Product Change Notification / LIAL-10HDQI000

CCB 3104.005 Initial Notice: Qualification of MPHL as a new final test site for selected ATMEGA48xx, ATMEGA88xx and ATMEGA168xx device families available in 32L TQFP (7x7x1mm) package.

CCB 3104.005
Pre and Post Change Summary
PCN#: LIAL-10HDQI000

QUALIFICATION PLAN SUMMARY

Tape and Reel - Carrier Tape

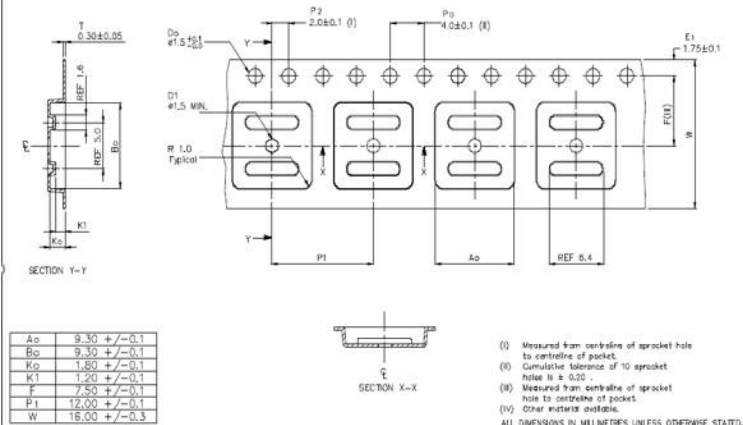
ANAP

W	P	A0	B0	K0	K1
16.00 (+/- 0.30)	12.00 (+/- 0.10)	9.30 (+/- 0.10)	9.30 (+/- 0.10)	1.80 (+/- 0.10)	1.20 (+/- 0.10)

Thickness	Color
0.30 (+/- 0.05)	Black

MPHL

Tape and Reel – Plastic Reel

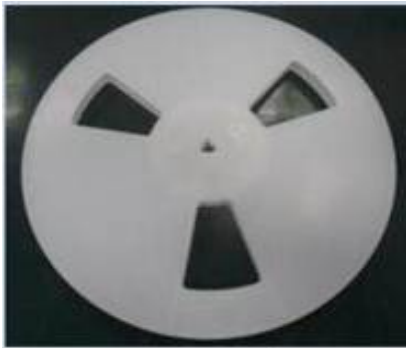
ANAP

Width	Outer Diameter	Inner Diameter
16	330.2 (+/- 2.0)	100

Color: White

MPHL

Color: White
D: 13"
Hub: 4"
W1: 17.5 mm
W2: 21.5 mm
